Zoning Staff Report

Date: August 8, 2023 Case Number: SP-23-003 Council District: 10

Owner / Applicant: Northwest Village (Fort Worth) Owner, LLC/ Adam Soto

Request: Add site plan for PD 1363 "PD/MU-2" Planned Development for all uses in High Intensity

NORTHWEST VILLAGE

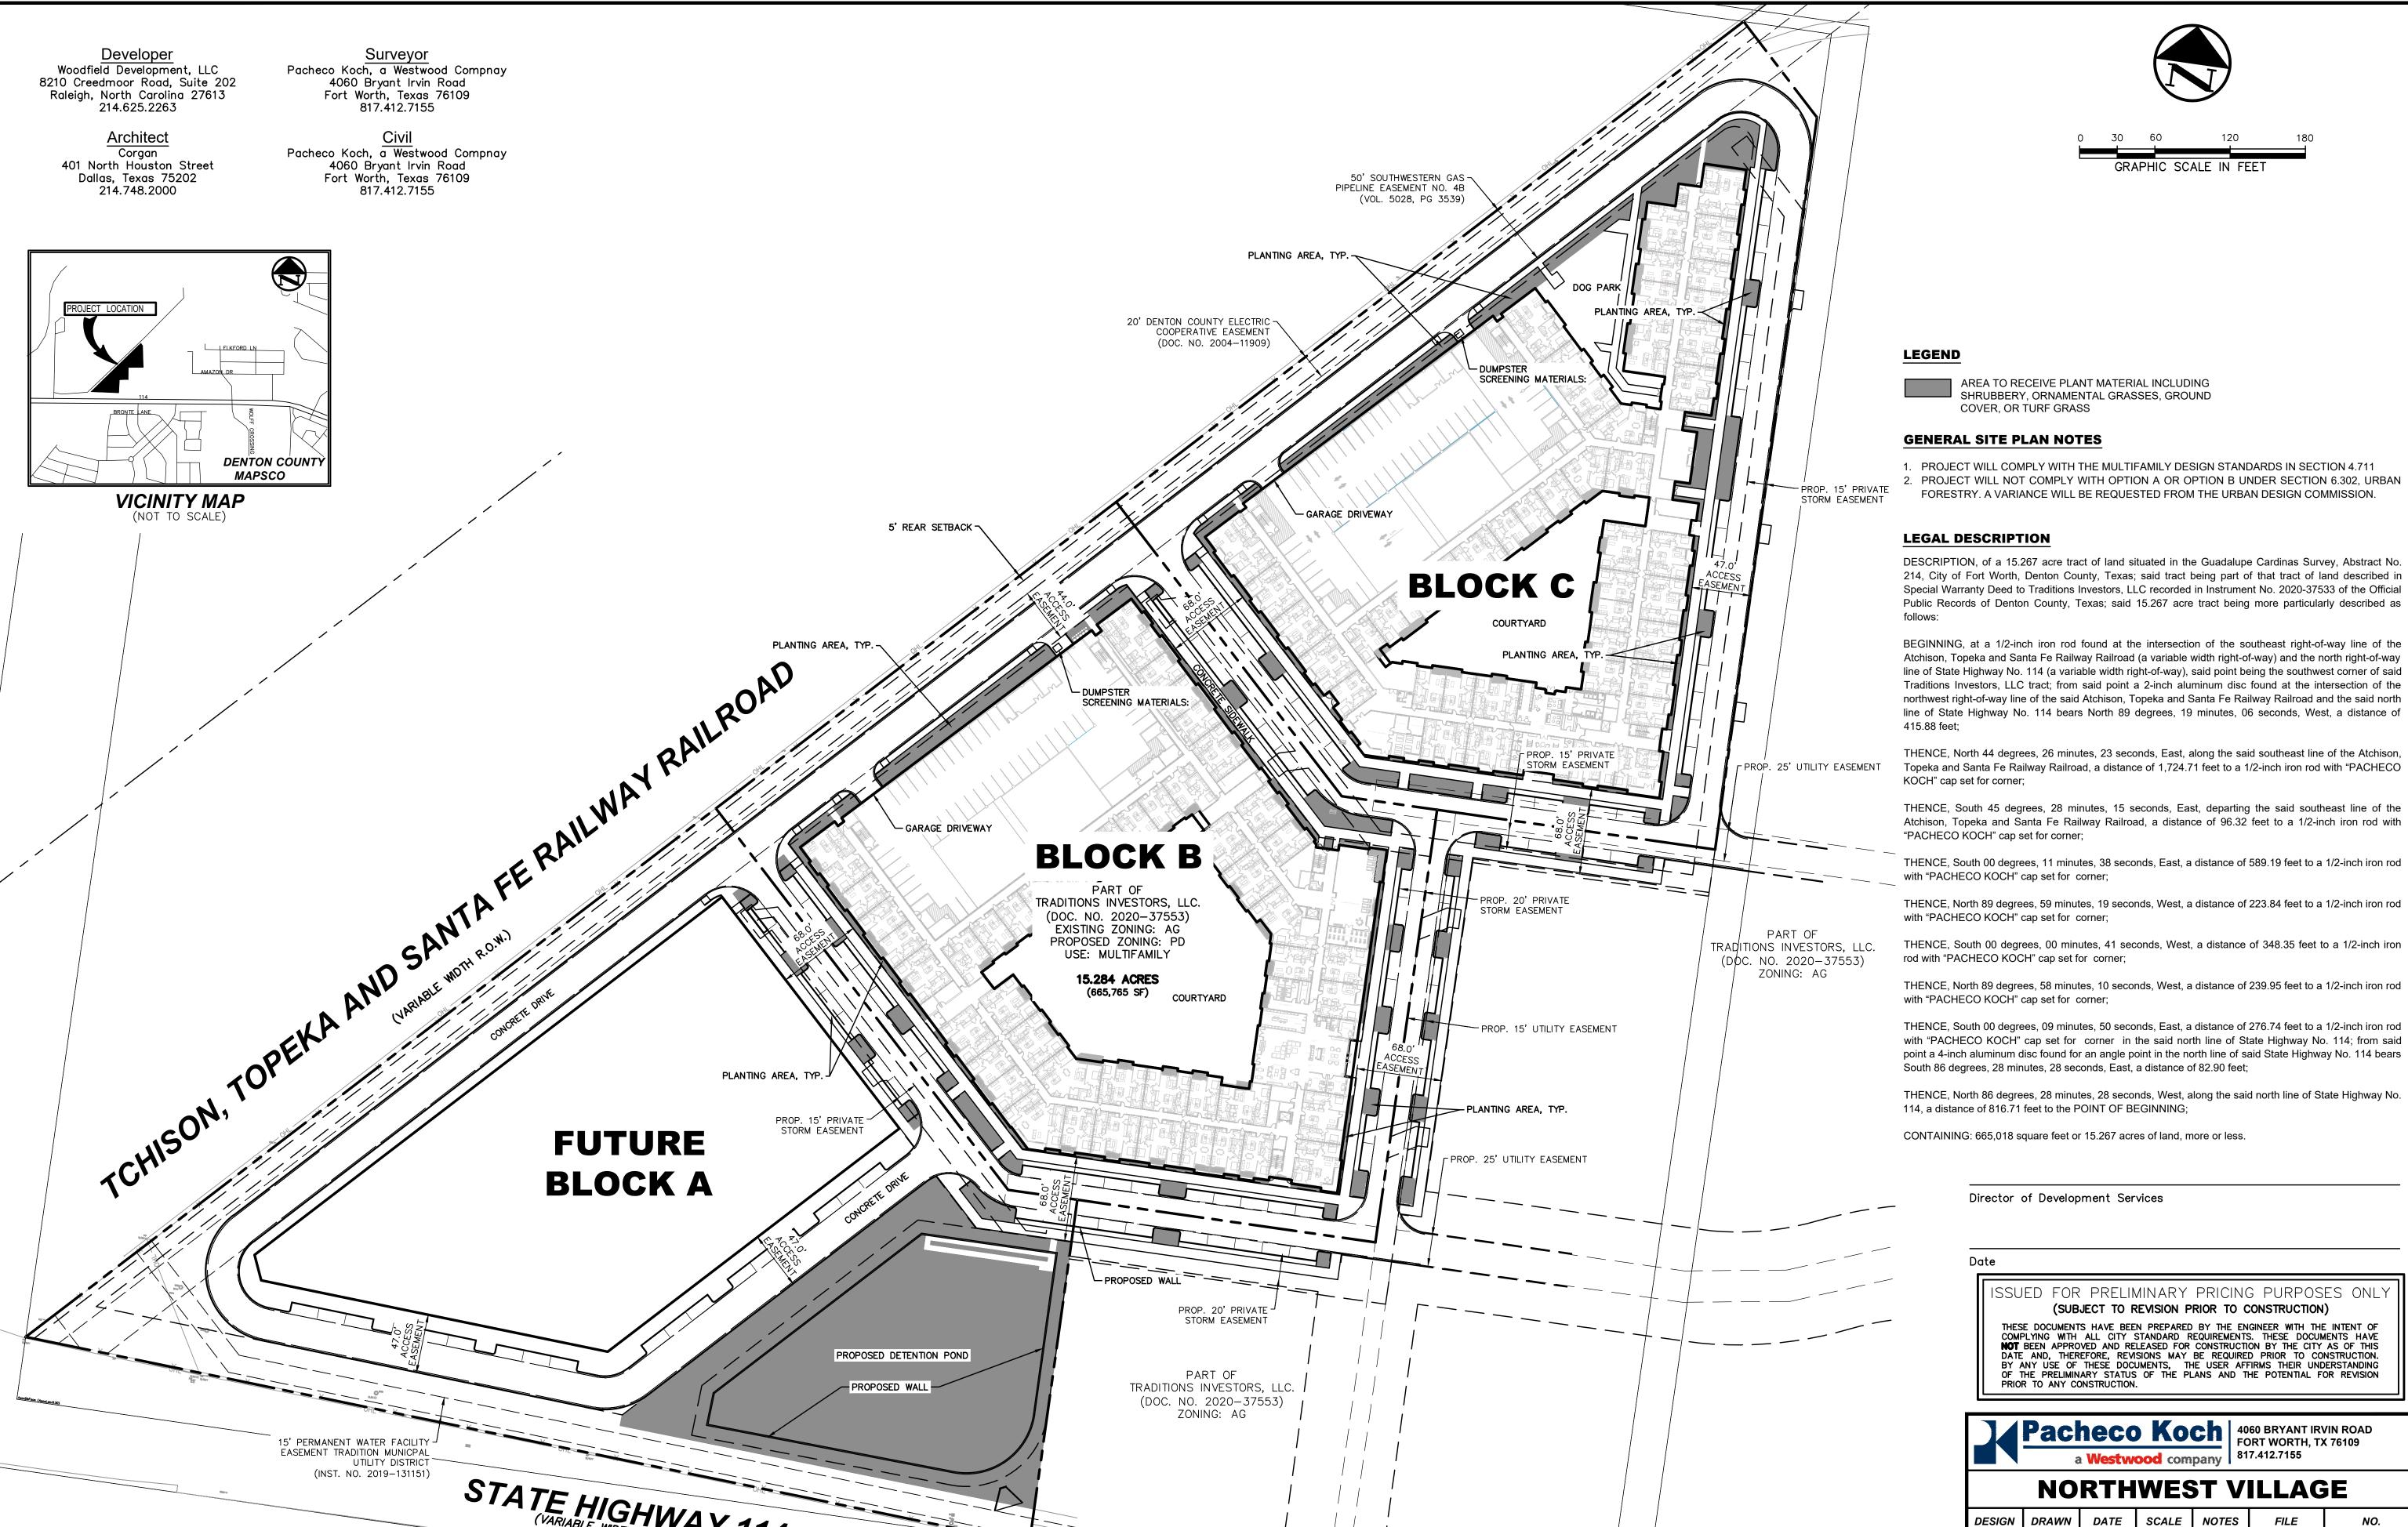
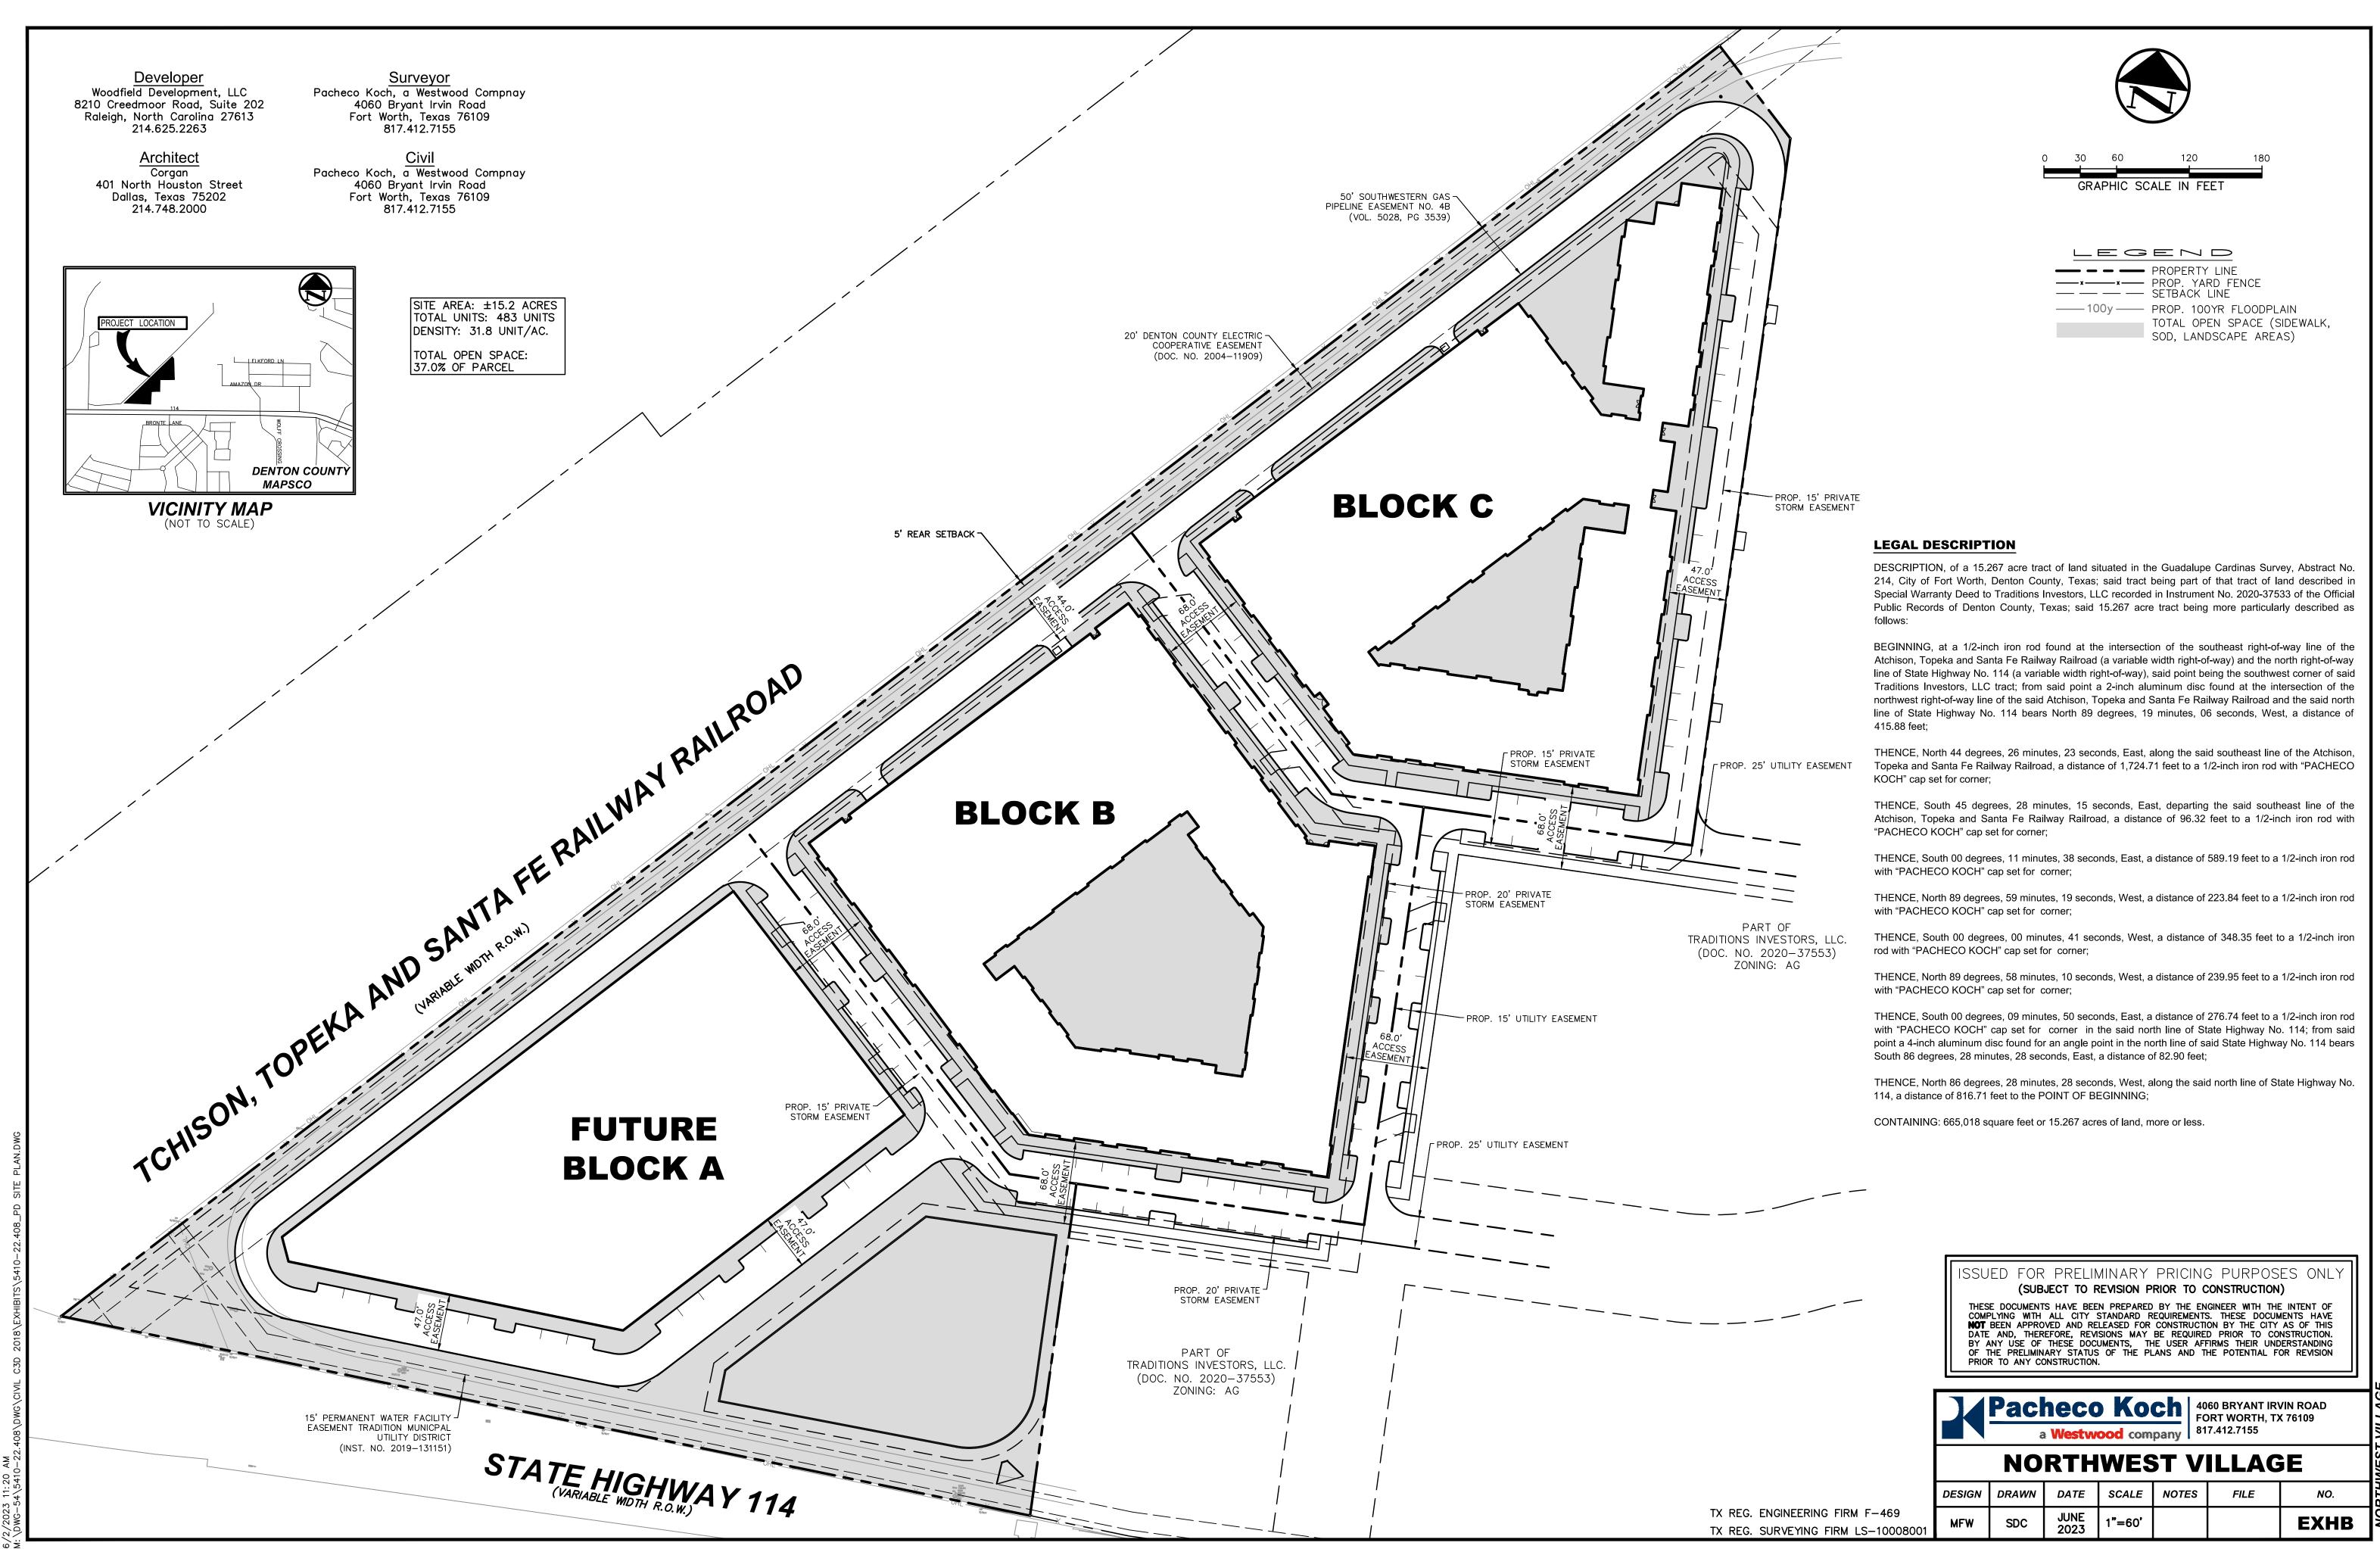
• Staff has reviewed the site plan that was submitted at the application; here are the notes:

• For site plans to be properly reviewed the site must be platted. If the site is not platted there could be problems that can affect the site plan and may result in the site plan being rereviewed at the Zoning Commission Board.

- Staff is unable to elevate if it meets the setback requirements, as there are no dimensions showing that they do follow the setback requirements.
- **Per Ord. 4.1302.d.2-** Primary Street setback min is 0' and max is 20', side street setback min is 0' and max is 20', rear yard setback min is 5', and common lot line is 0'. This development according to the PD this proposal will be considered a campus development. With that said, Interior buildings constructed as part of a campus development may be set back from the property line more than 20 feet if at least 50 percent (%) of the public street frontage on each block face within the development contains buildings within the maximum setback of 20 feet. Interior buildings setback farther than 20 feet may not be constructed until the 50 percent (%) requirement has been satisfied.

• The site plan is following the min 2 stories and the max 5 stories.

- The parking is complying.
- **Per Ord. 4.1302.e.2** Apartments require 0.75 to 1 space required per bedroom; Plus, 2 spaces per 500 square feet of leasing office and/or social rooms. This proposed project has 675 and 15,888 leasing offices and social rooms. The minimum requirement for this project is 739 parking spaces and a maximum of 924 parking spaces. This project is providing 821 parking spaces.
- Please review Façade Design standards for the parking structure facades
- Staff is unsure what is being considered the main ROW, please clarify and follow the standards Ord. 4.1302.e.3.

- The portion of the ordinance is not complying.
- Enhanced Landscaping and Pedestrian Lighting Requirements Per Ord. 4.1302.f.2- The site plan is not in compliance with this ordinance. Staff has not seen any landscape enhancements or pedestrian lighting.
- Landscaping in Parking and Driveway Areas- The MU-2 district is intended to create a public environment in which pedestrian safety, interest, and comfort are paramount.

- Therefore, parking areas that front public streets and pedestrian pathways shall be screened to minimize pedestrians' view of parked vehicles and the impact of vehicle headlights.
- **Urban Forestry-** Developments with surface parking lots must provide 40% canopy coverage over new, expanded, or reconstructed surface parking. Submission of applicable urban forestry plans for review shall comply with Section 6.302 (g), Urban Forestry Plan/Permits.

- Parking Structure Facades- All parking structure facades that face a public space must be designed to incorporate architectural elements and materials that complement the adjacent building or buildings in the area. Ground-level screening must be incorporated to minimize the visual impact of garages and parked cars at the pedestrian level. Landscaping, including trees and shrubs, may be utilized for screening purposes but must screen at least 50% of pedestrian-level parking garage facades immediately upon installation, with species selected to eventually provide a full 100% screening.

- Facade Variation, Per Ord. 4.1302.g.2- Each new building facade that is greater than 50 feet in width and is oriented to a publicly accessible street or open space must incorporate each of the following scaling elements. For building facades less than 50 feet in width, a minimum of two elements are required. The site plan did not include elevations to show the façade variations. Staff can not determine if a waiver will be needed, but staff will need to review it before any approved site plan.

- Building Entries, Per Ord. 4.1302.g.5- The intent of building entries is to create a pedestrian-oriented development in which buildings are oriented toward publicly accessible streets and sidewalks. Please follow the standards for building entries, staff was unable to review due to a lack of information shown on the site plan.
